Preliminary Consultation
MONTGOMERY COUNTY HISTORIC PRESERVATION COMMISSION
STAFF REPORT

Address:	6700 Needwood Road, Derwood	Meeting Date:	6/12/2024
Resource:	Master Plan Site #22/35 Needwood Mansion	Report Date:	6/5/2024 <u>6/7/2024</u>
Applicant:	Montgomery Parks (Eileen Emmett, Agent)	Public Notice:	5/29/2024
Review:	Preliminary Consultation	Tax Credit:	N/A
Permit Number:	1071486	Staff:	Chris Berger
Proposal:	Building alterations for ADA accessibility improvements, tree removals, and other alterations.

1
AD1.U1 DEMOLITION PLAN-OVERALL- LEVEL U1

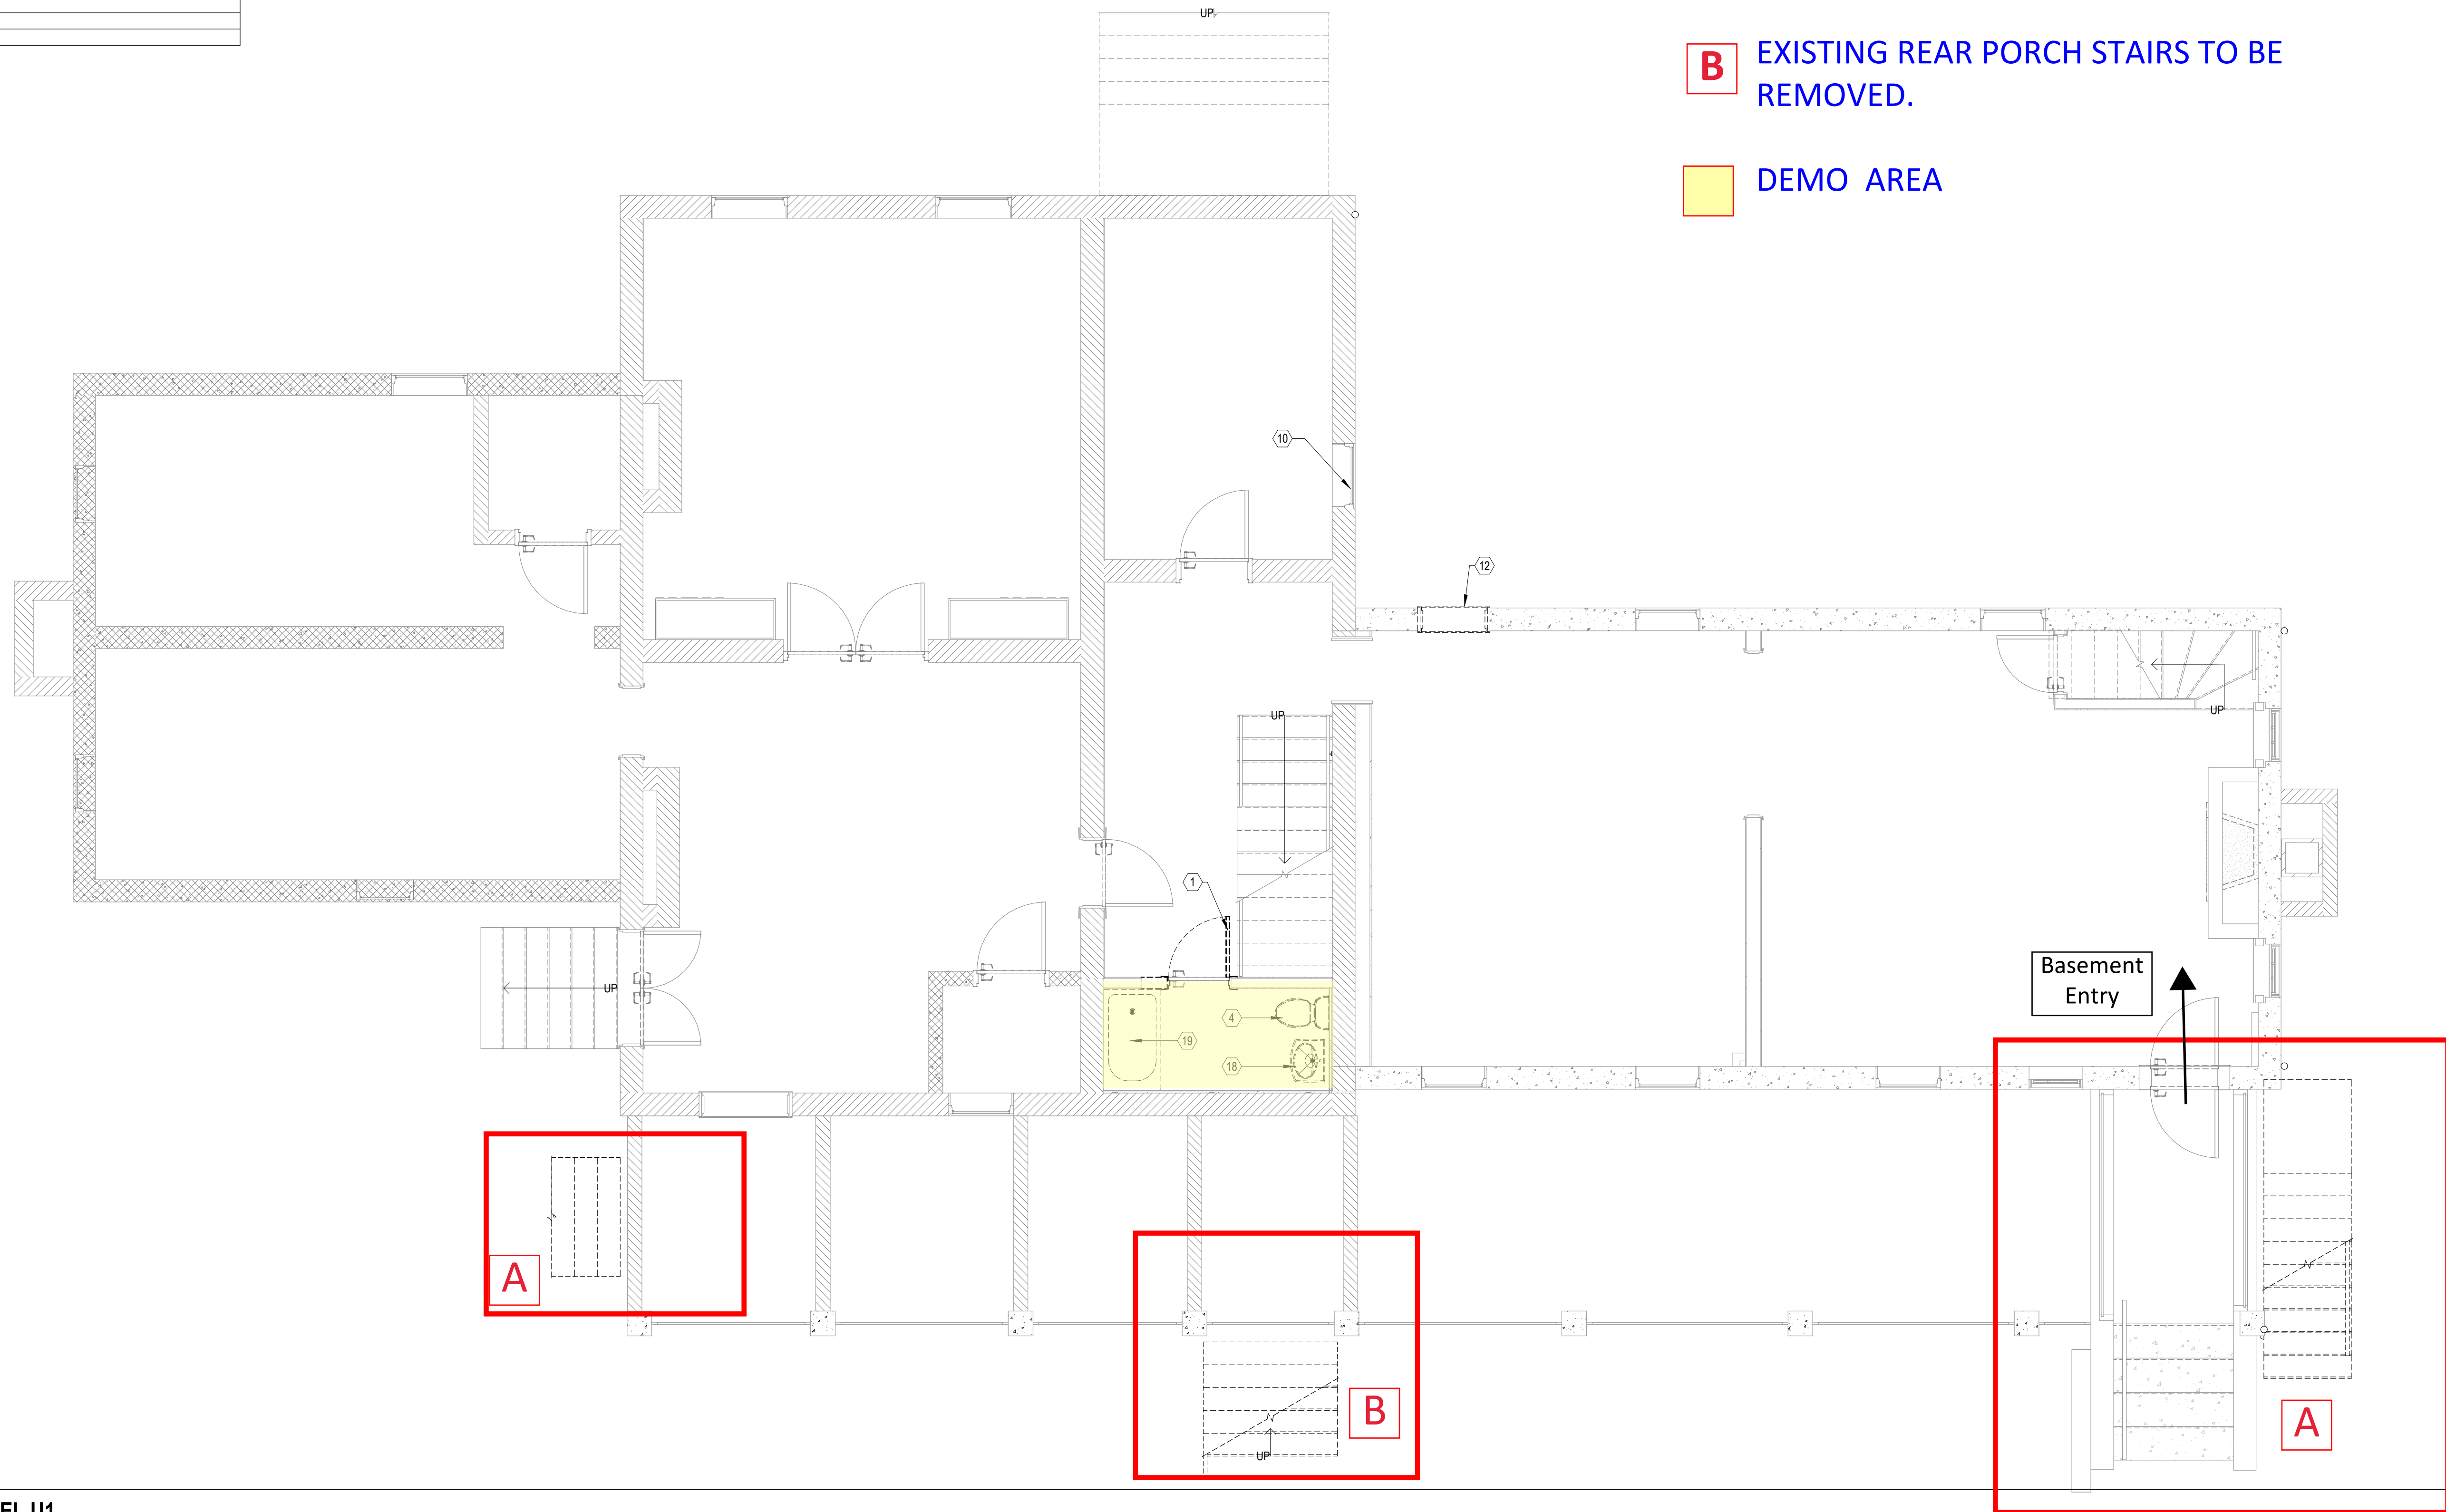
As part of the HAWP, staff seeks specifications and a drawing on the proposed ADA hardware proposed for the rear main entry door. The screen door at that entrance also will be removed to improve ADA accessibility; staff supports the removal because the door is not a substantial alteration. The two proposed condenser unit locations should be added to the site plan for the HAWP review. The pad dimensions and material should be included on the plan. Staff supports the alteration of the rear stairs on the left-side elevation.
